SCOPE OF PROJECT CHANGES:

PERMIT DRAWINGS

CLARKSON RESIDENCE

1 PROPOSED EAST ELEVATION
1/4" = 1'-0"

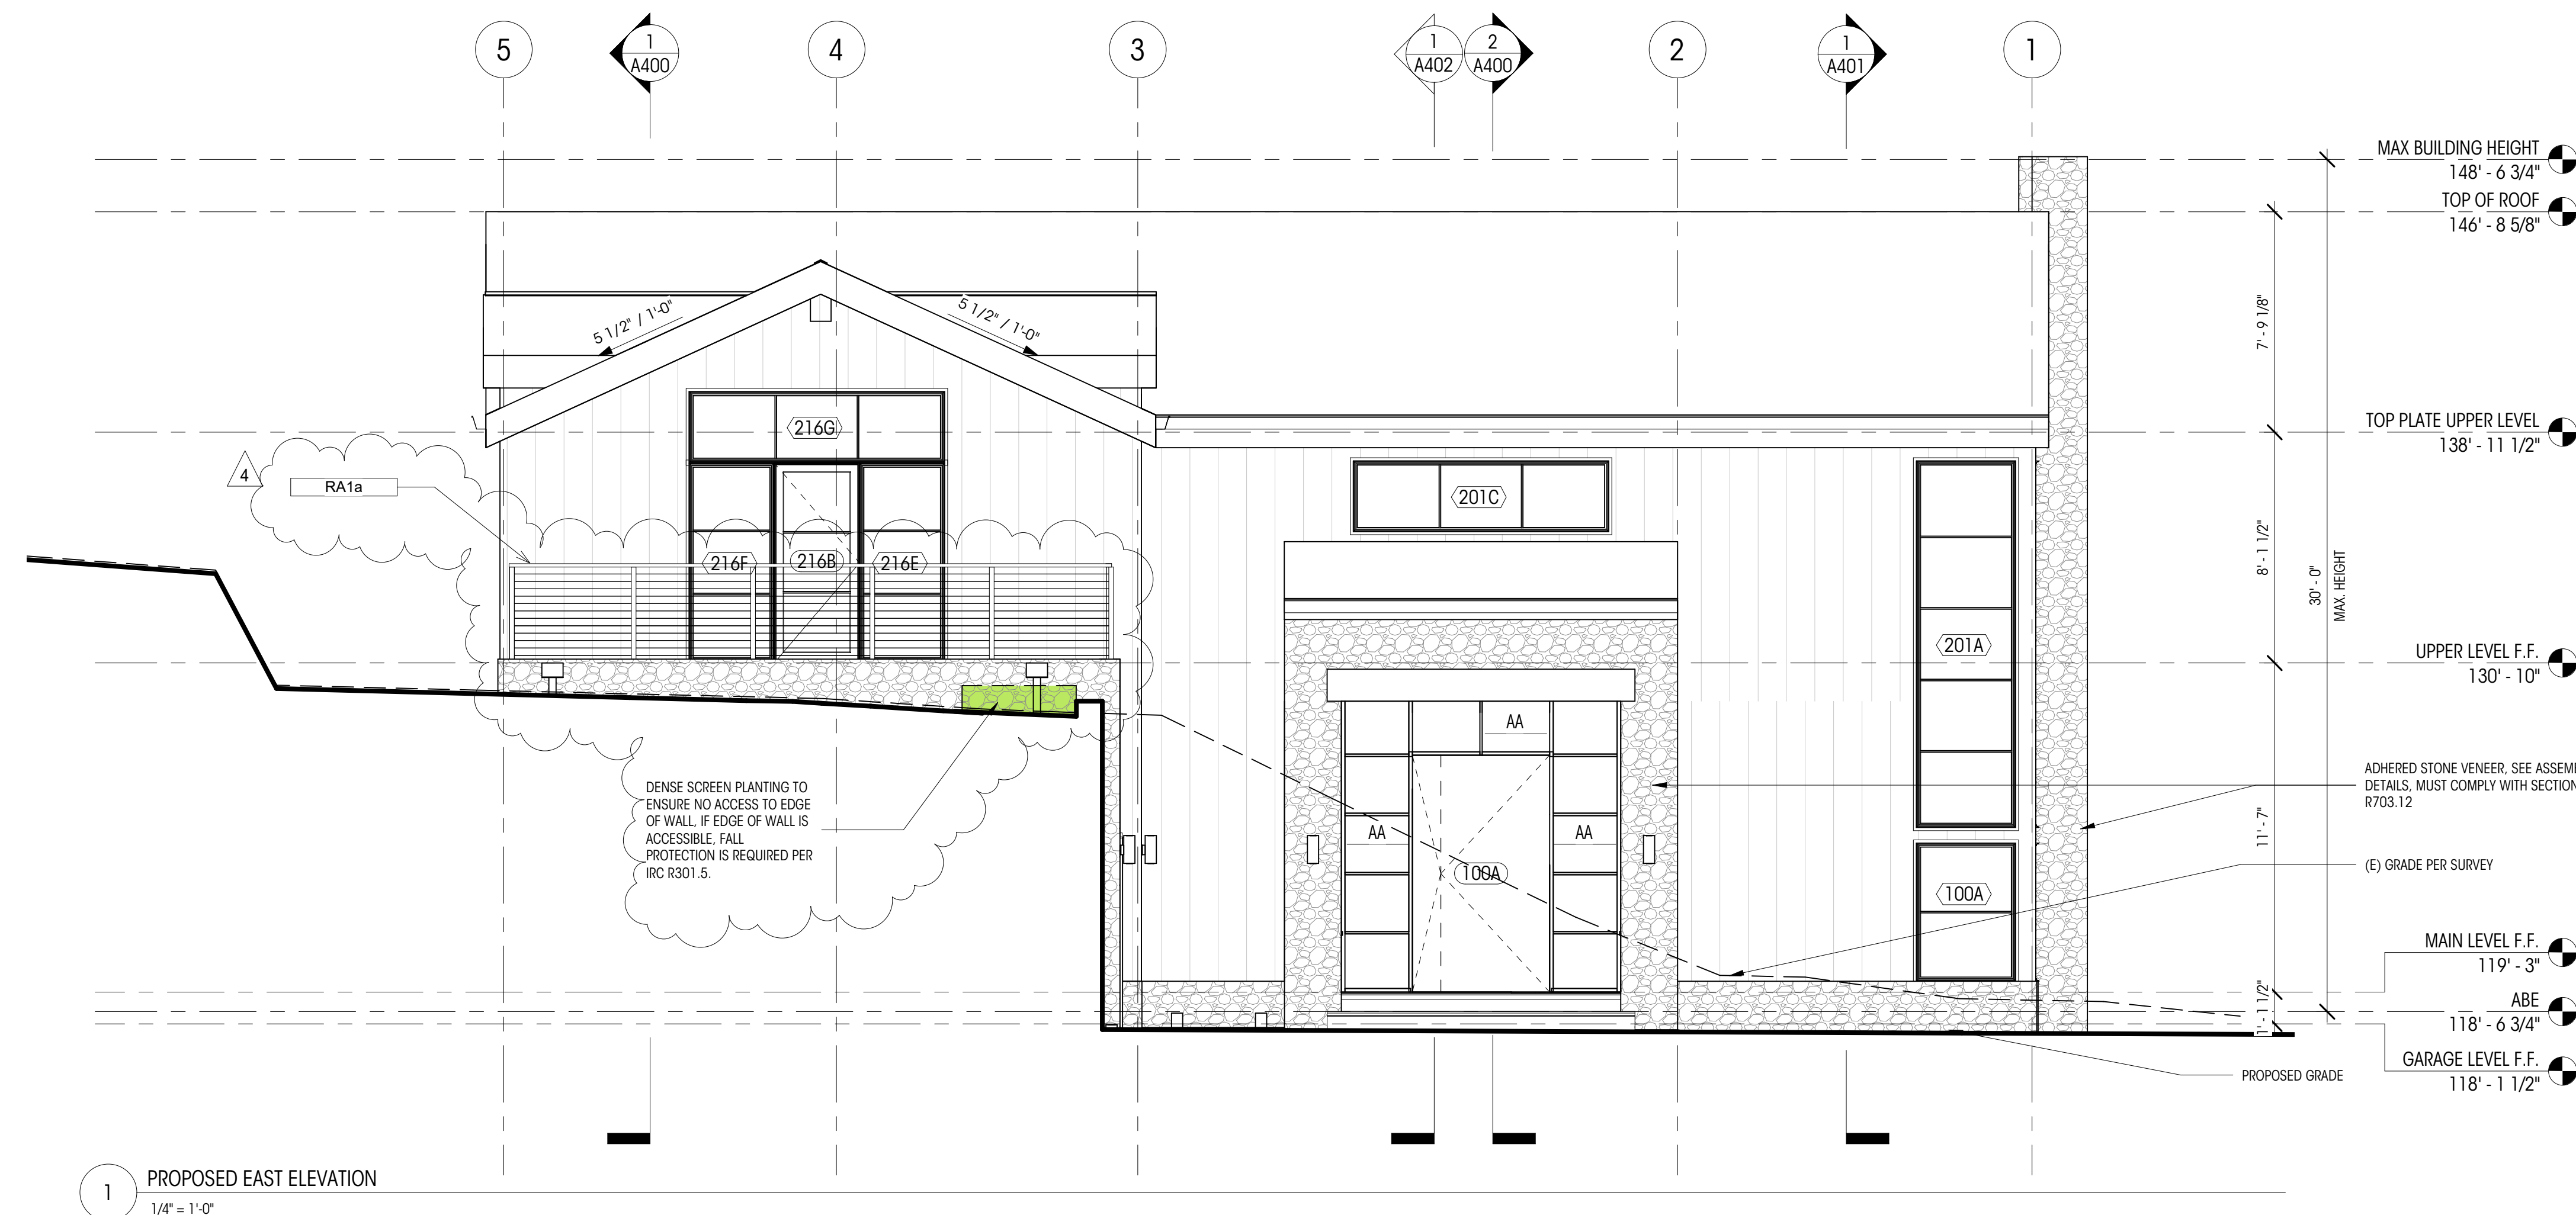
- CHANGE ROOF OF AND EXTEND WESTERN PATIO TO THE WEST AND SOUTH
- ADDED DORMERS AT UPPER LEVEL BONUS ROOM
- EXTEND GARAGE EAST INTO FRONT YARD SETBACK AS ALLOWED BY CODE 19.02.040.D
- WINDOW SIZE & LOCATION CHANGES
- LEVEL CHANGES:
 - a. DRIVEWAY & GARAGE LEVEL DROP BY 12"
 - b. BASEMENT LEVEL DROP BY 12"
 - c. FRAMED FLOOR 12" ABOVE BASEMENT FLOOR.
 - d. CHANGE TO ABE AS A RESULT OF EXTENDED GARAGE AND EXTENDED COVERED DECK
 - e. CHANGE TO MAX HEIGHT AS A RESULT OF THE ADJUSTMENT TO THE ABE
 - f. TOP PLATE LEVEL ADJUSTED UP 2 5/8".

1 EAST WEST SECTION 1
1/4" = 1'-0"

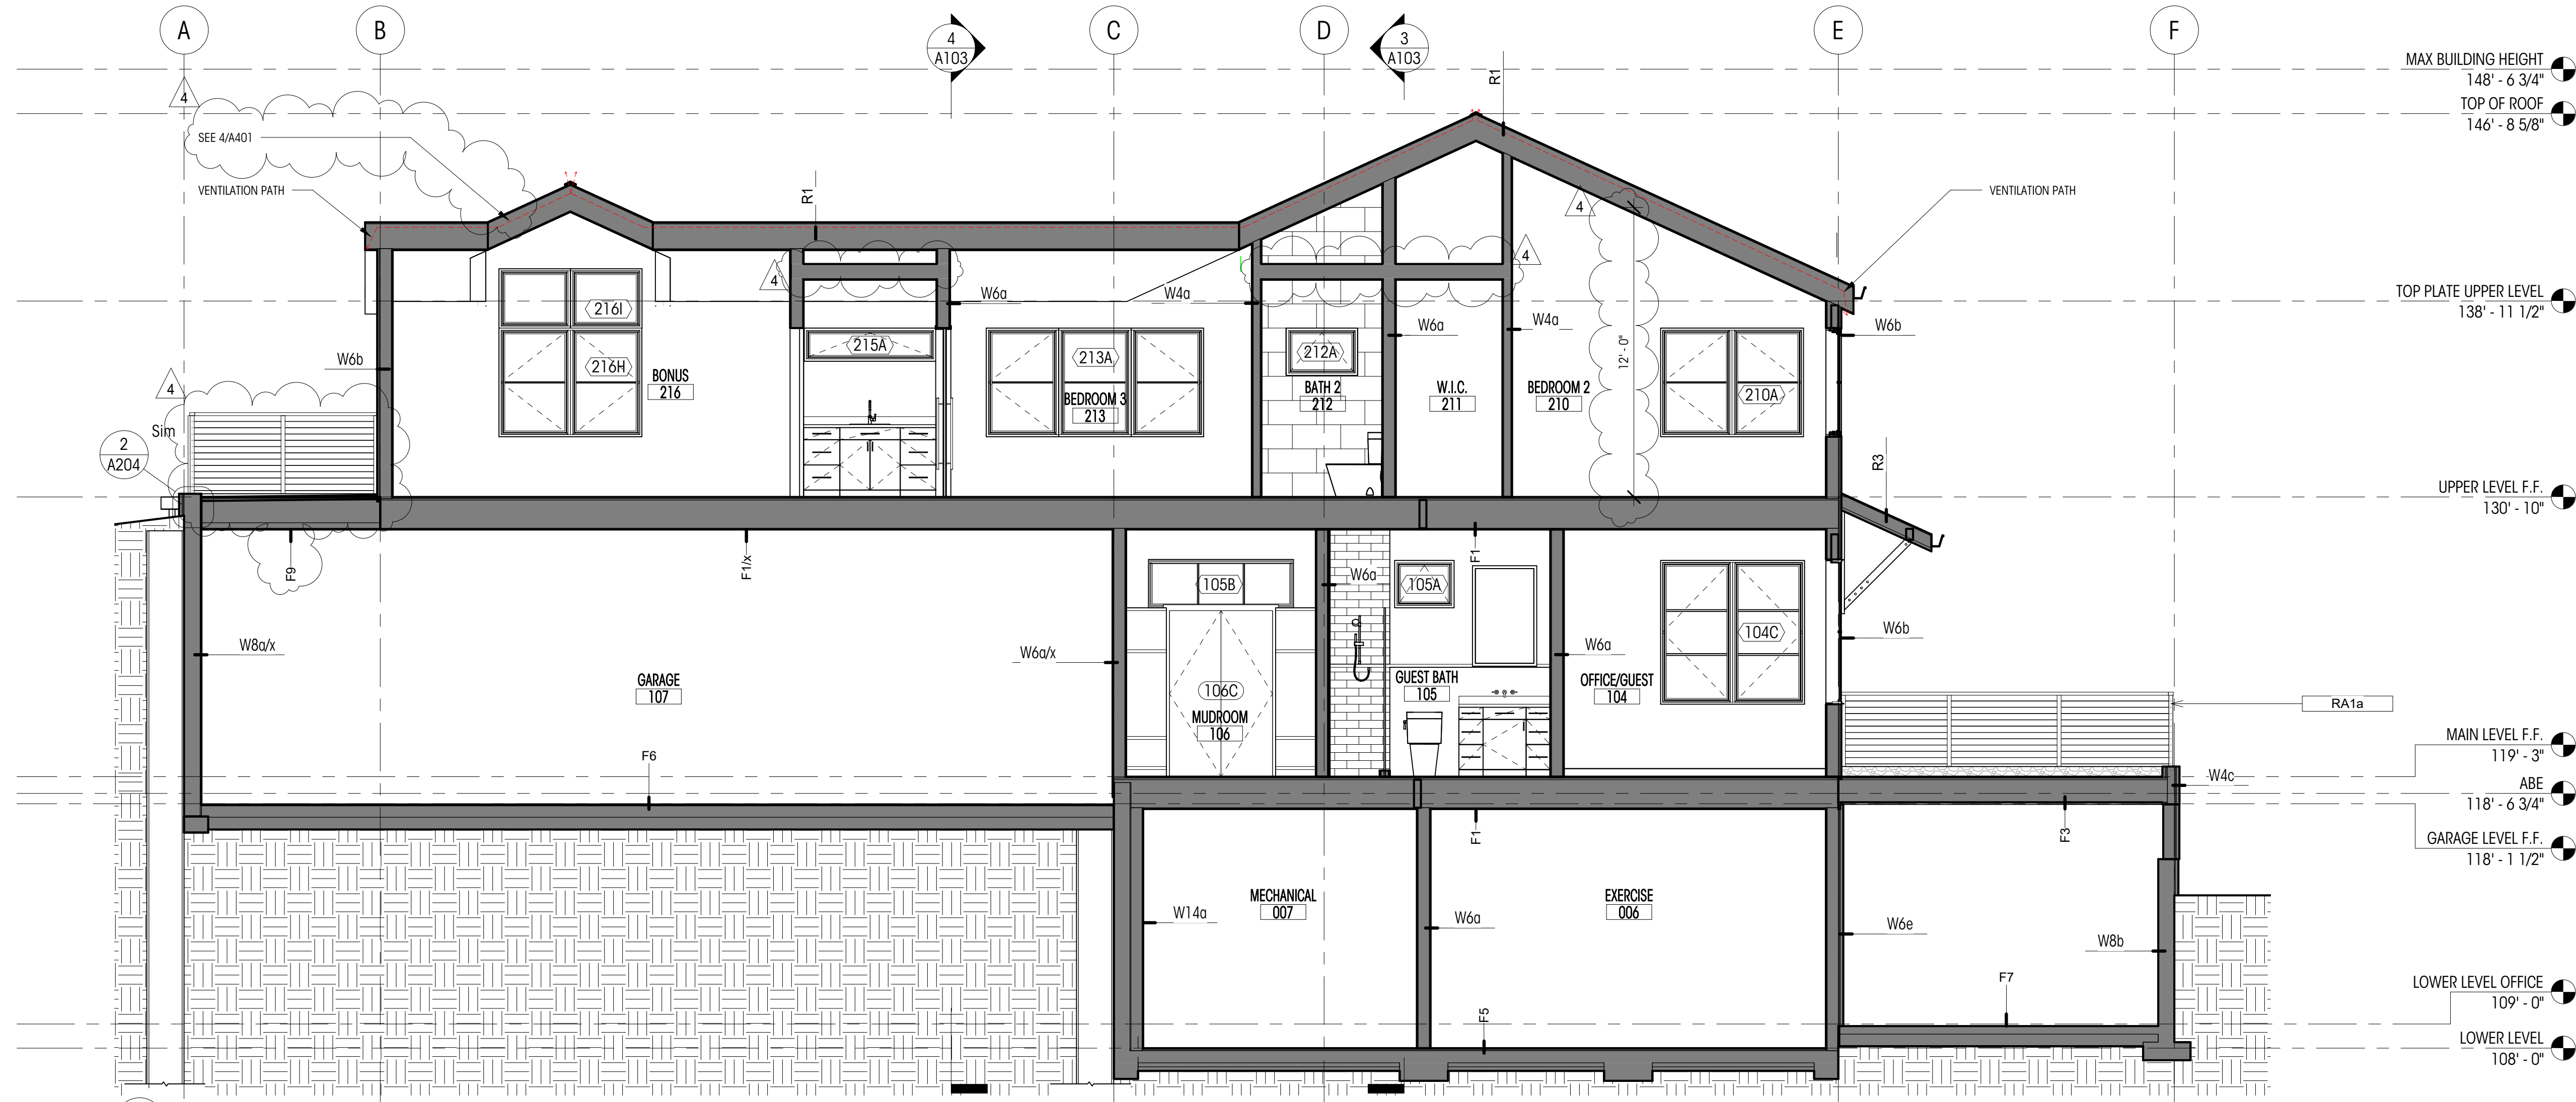
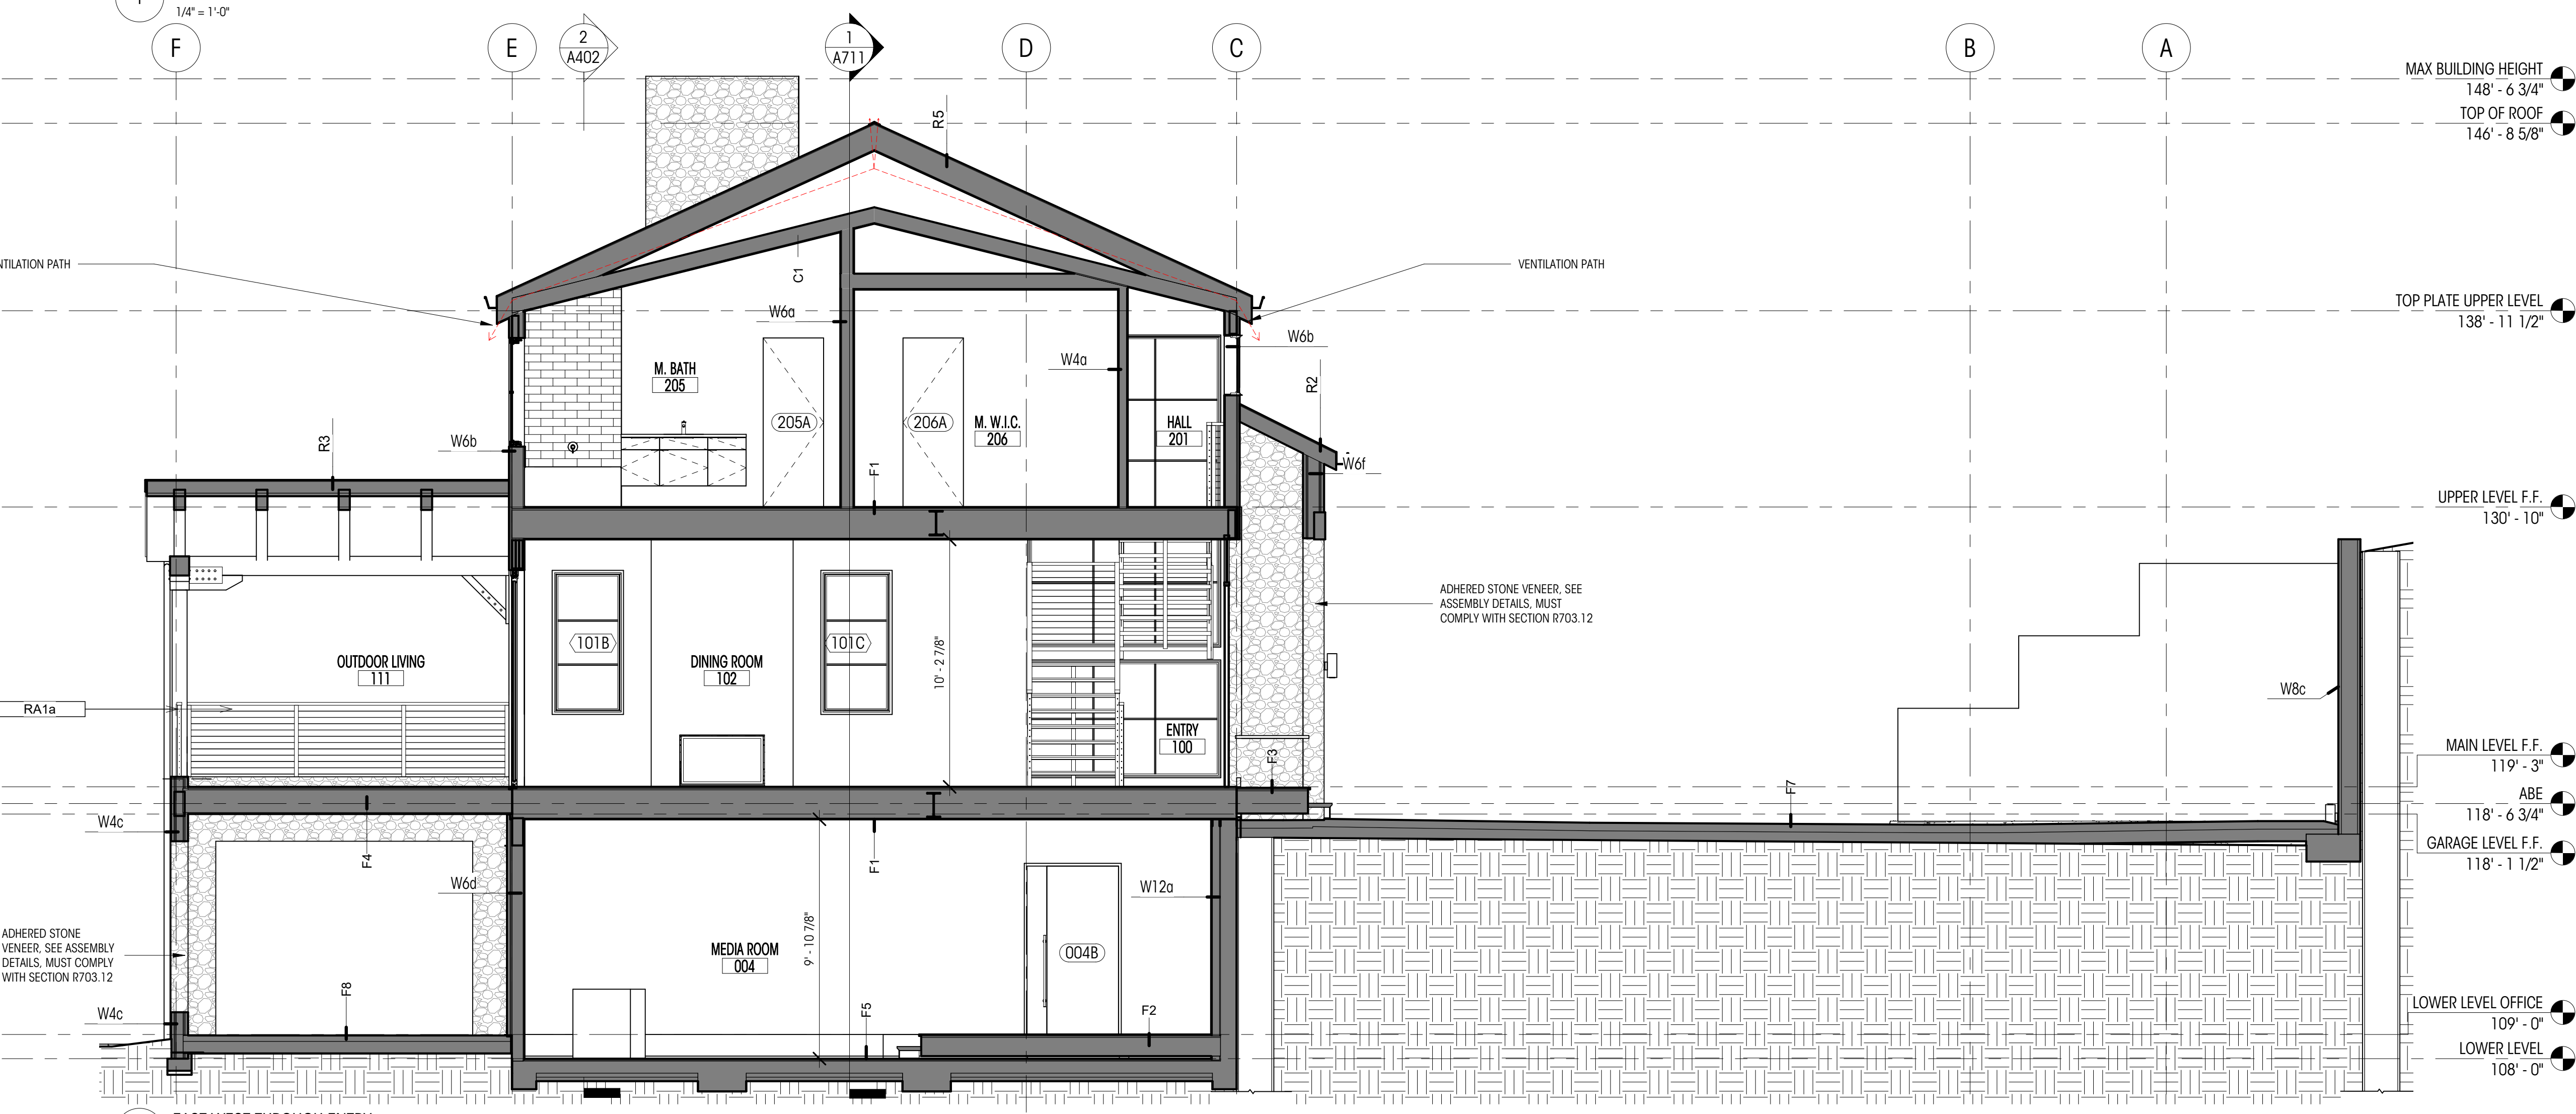
- VIEW NUMBERING UPDATED AND ADJUSTED FOR CLARIFICATION
- CHANGE ROOF OF AND EXTEND WESTERN PATIO TO THE WEST AND SOUTH
- ENTRY DESIGN CHANGE
- ADDED DORMERS AT UPPER LEVEL BONUS ROOM
- EXTEND GARAGE EAST INTO FRONT YARD SETBACK AS ALLOWED BY CODE 19.02.040 D
- SHEET LAYOUT ADJUSTED FOR ORGANIZATIONAL PURPOSES
- PREVIOUS "VIEW 1" HAS MOVED TO SHEET A401 AND STAYED "VIEW 1"
- LEVEL CHANGES:
 - a. DRIVEWAY & GARAGE LEVEL DROP BY 15"
 - b. BASEMENT LEVEL DROP BY 12"
 - c. UPPER LEVEL DROP BY 2"
 - d. FRAMED FLOOR 12" ABOVE BASEMENT FLOOR.
 - e. CHANGE TO ABE AS A RESULT OF EXTENDED GARAGE AND EXTENDED COVERED DECK
 - f. CHANGE TO MAX HEIGHT AS A RESULT OF THE ADJUSTMENT TO THE ABE
 - g. TOP PLATE LEVEL ADJUSTED UP BASED ON ROOF FRAMING
 - h. ROOF OF ROOF HAS LOWERED AS A RESULT OF REDUCED ROOF PITCH
